Our Case Number: ABP-314724-22

Re: Railway (Metrolink - Estuary to Charlemont via Dublin Airport) Order [2022]
Metrolink. Estuary through Swords, Dublin Airport, Ballymun, Glasnevin and City Centre to
Charlemont, Co. Dublin

Metrolink submission (Railway Order) 2022

This submission focuses solely on traffic, vehicular access & safety concerns I have as a resident, with regard to the proposed Station at Glasnevin.

TII's Traffic Plan?

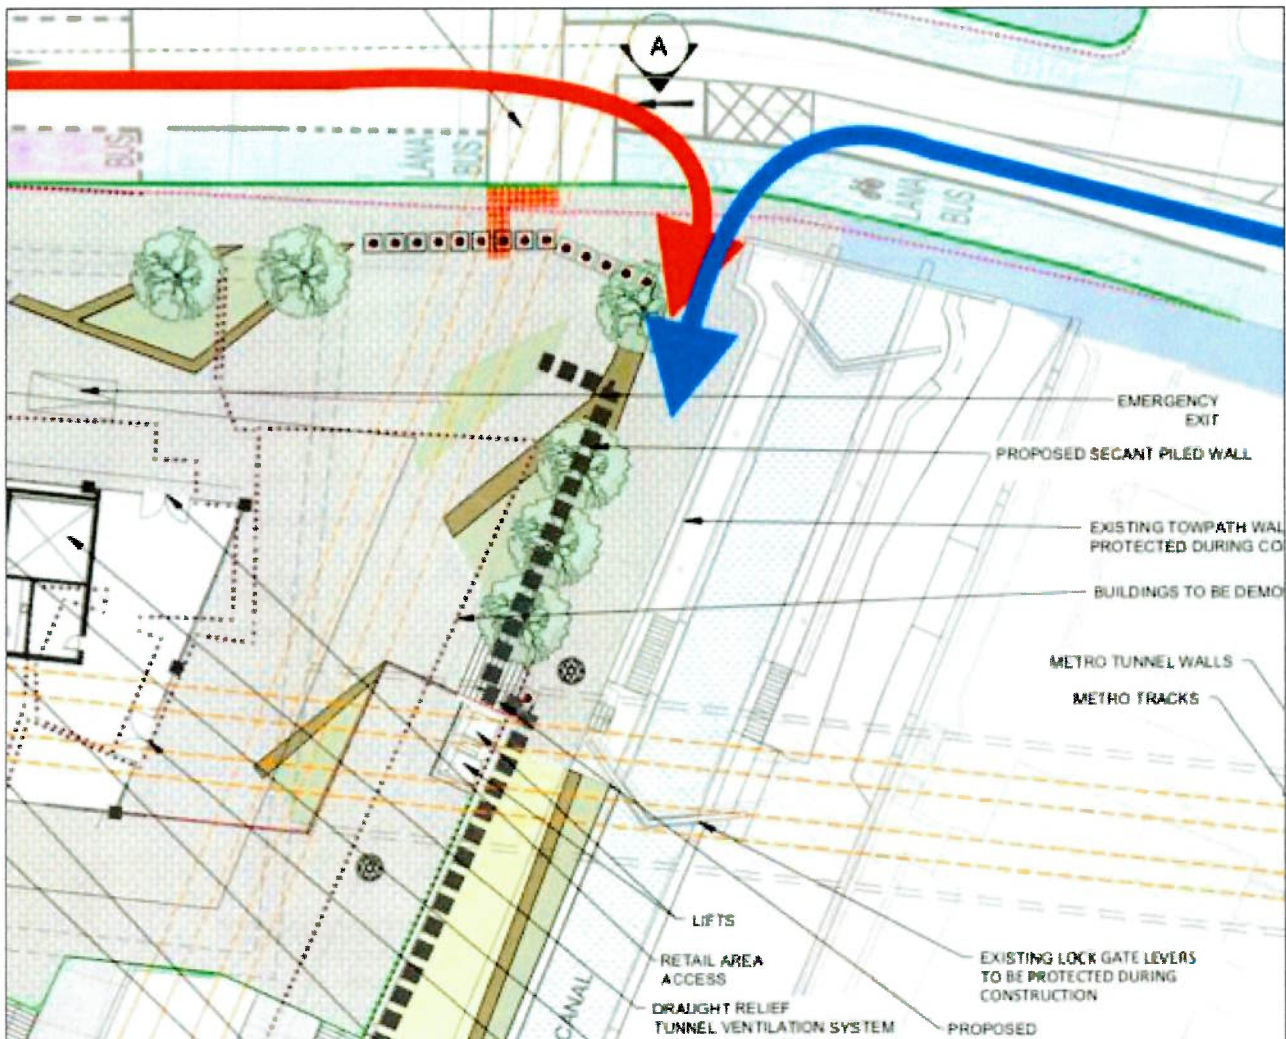
The drawings above & below are TII's most recent drawings, the blue and red arrows are my own and indicate exiting and entering vehicles left (North) and right towards the city centre.

I can find no detail in new plaza layout, indicating how traffic should exit and enter. Will there be a filter light for instance? Also I see only one yellow junction box, in the outer lane, where obviously 2 would be needed, to stop vehicles in the bus lane blocking vehicles exiting from the Royal Canal Way

Enter right coming from the North & left from Phibsboro / City Centre

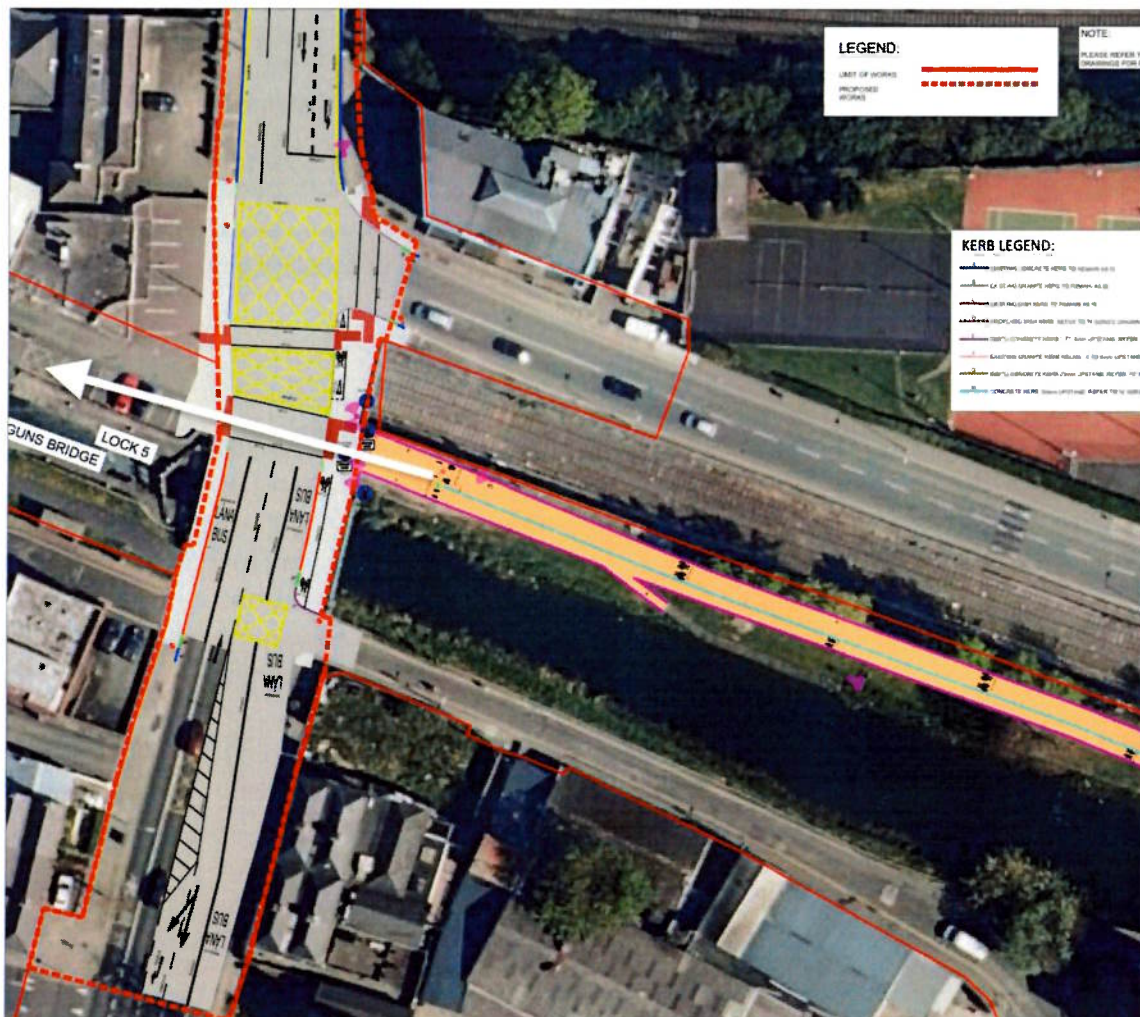
In the image above, where should traffic approaching from the north (red arrow) wait before pulling across? With the absence of a filter light, it would be absolutely essential that there should be no pedestrians blocking vehicles trying to pull across.

How is this to be achieved?

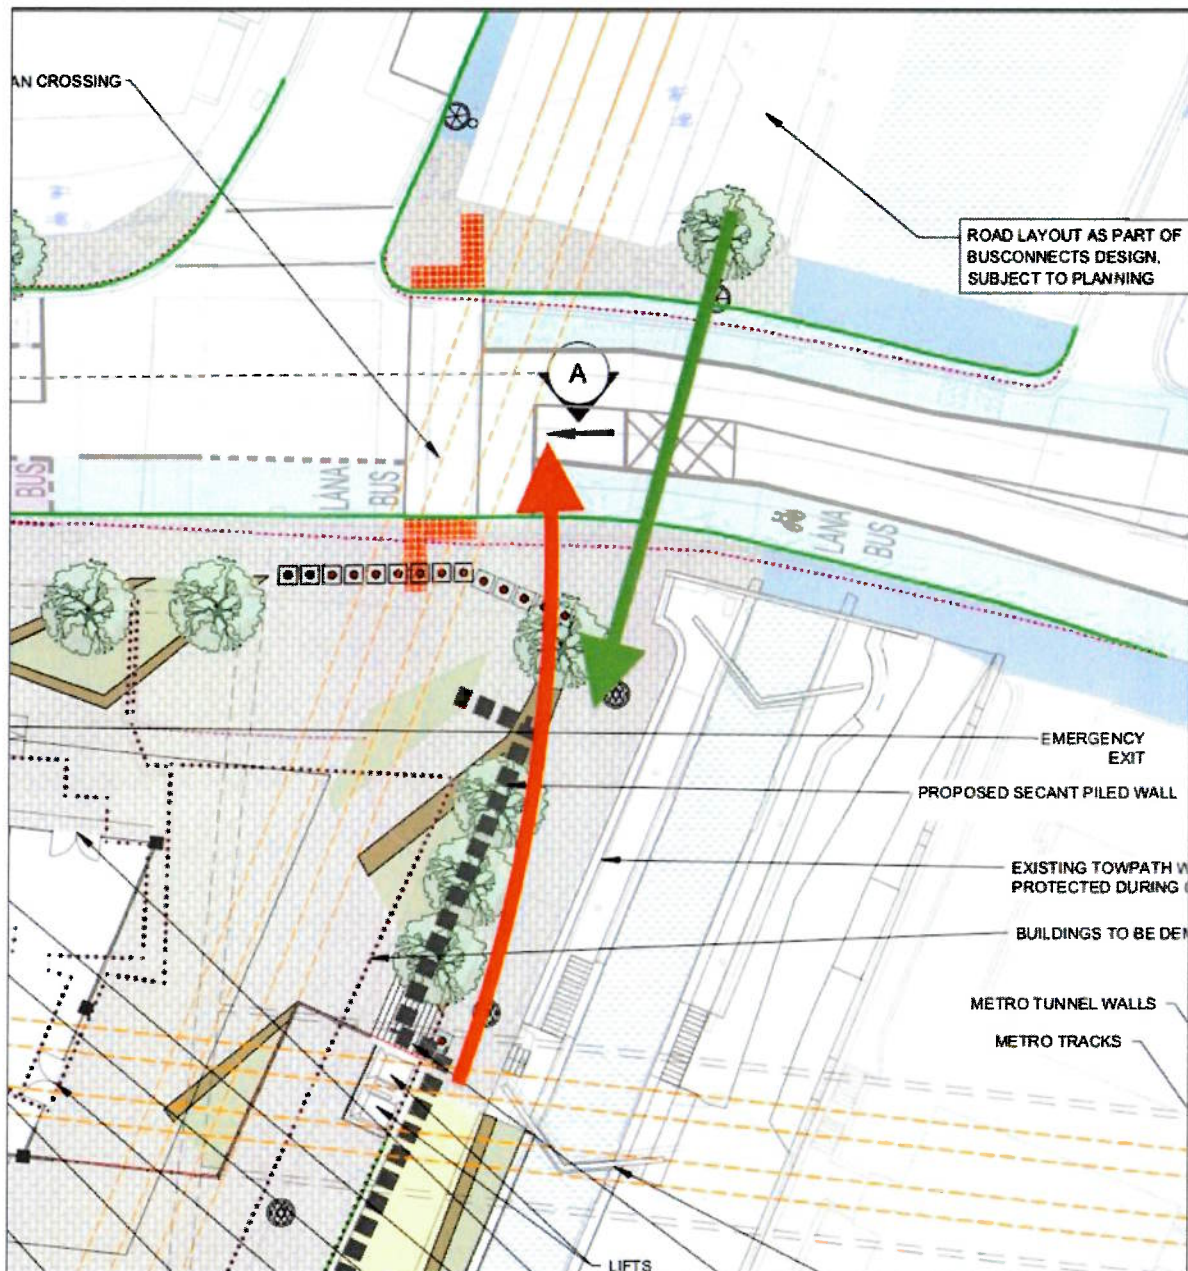
Above is a photo of the ongoing Royal Canal Greenway works due to be completed Q.2 2025. It is very hard to see how TII Metrolink & DCC's Greenway plans marry

Has there been consultation between the two bodies? I believe this is absolutely essential with large costly state infrastructure overlapping like this. Otherwise it is the unfortunate tax payer that pays the cost, both financially and in time wasted.

Above Red arrow indicates RCW Vehicular Traffic,
Green arrow RCG Commuters

Metrolink drawings at present do not allow sufficient room for exiting & entering vehicles combined with the ever, growing Greenway Commuters.

Dangerously Narrow Section of Road

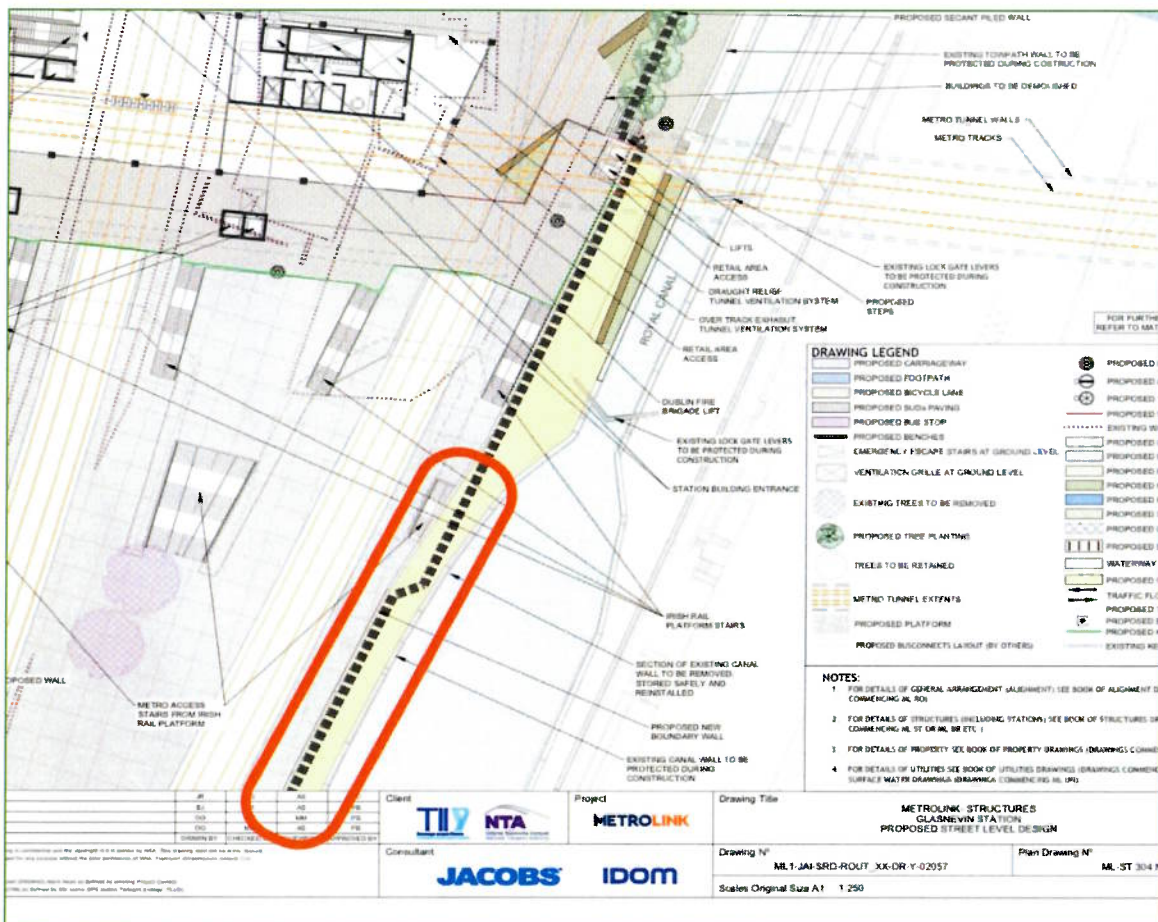
I have very serious concerns regarding vehicular and pedestrian safety along the section of towpath between the station and the canal. See below.

The towpath is only 3.3m wide here and all vehicles must pass this point. It stretches for approx. 50m and is undoubtedly the greatest point of danger along the towpath, as the water is very deep here and there is no riparian verge.

TII's response to previous queries about the final width of the towpath here was that “**the access road will be no narrower than it presently is**”. However, this worries us greatly, as at present it is already highly dangerous and will only get worse when the station is up and running, due to the inevitable increased footfall and frequency of bicycles & scooters.

Surely TII would have to adhere to legal safety standards, before reopening this stretch of road to the public? And 3.3m does not meet those standards.

I believe TII needs to address this issue immediately, as it might require difficult structural changes to the plan at this point.

Narrowest section of towpath (highlighted in red) approx. 50m long

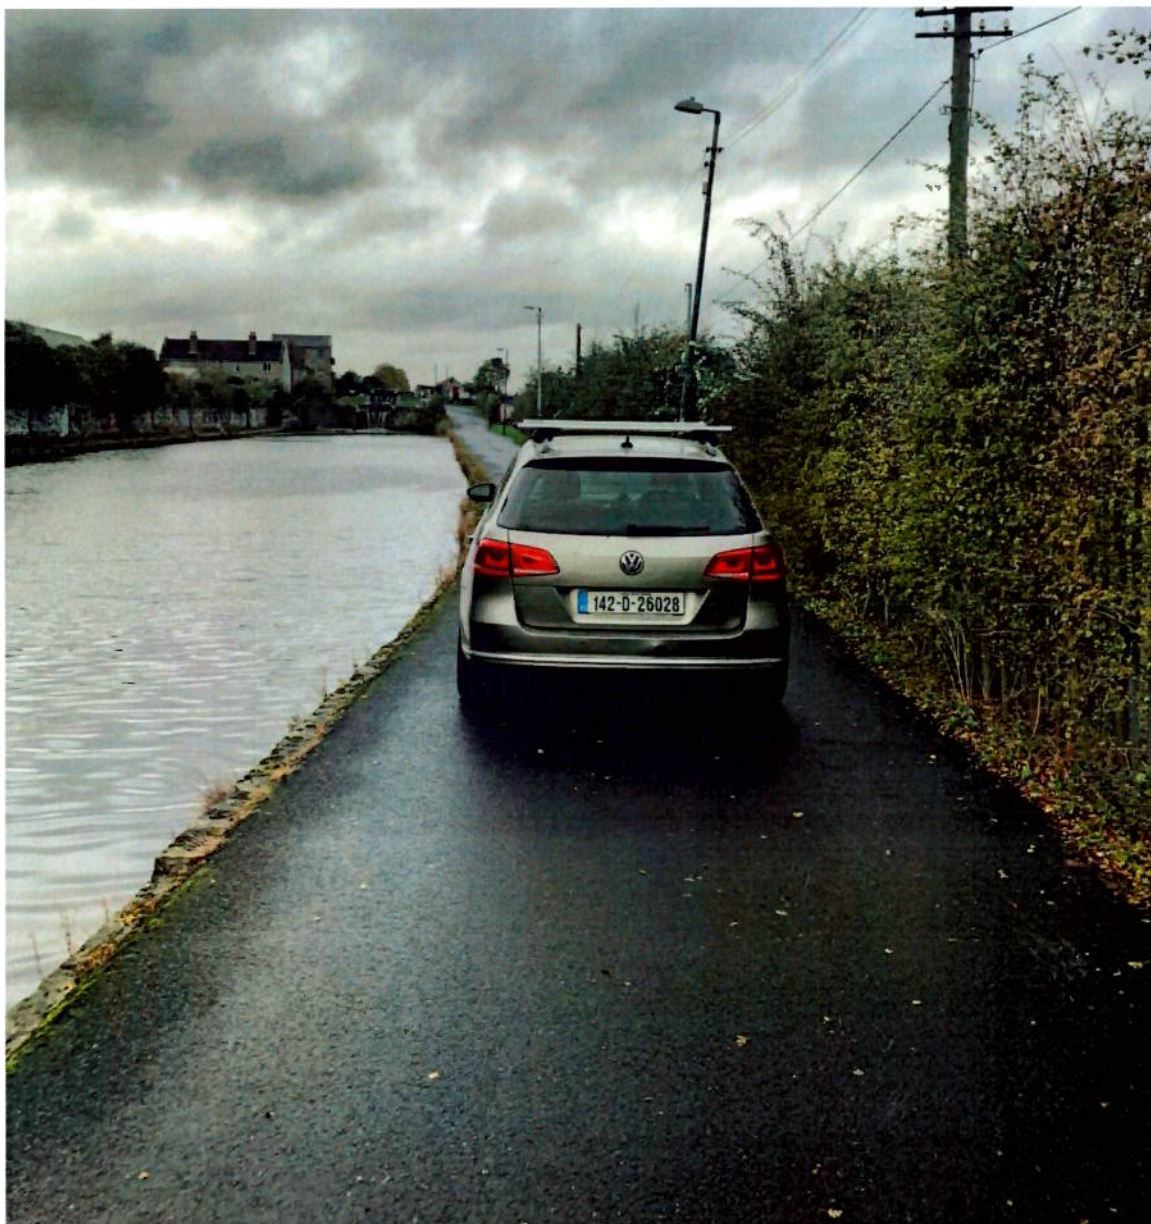
It is very concerning to us as community, that our right of way has repeatedly been underestimated and often largely overlooked in Metrolink's drawings.

= Narrowest Section of Towpath Access
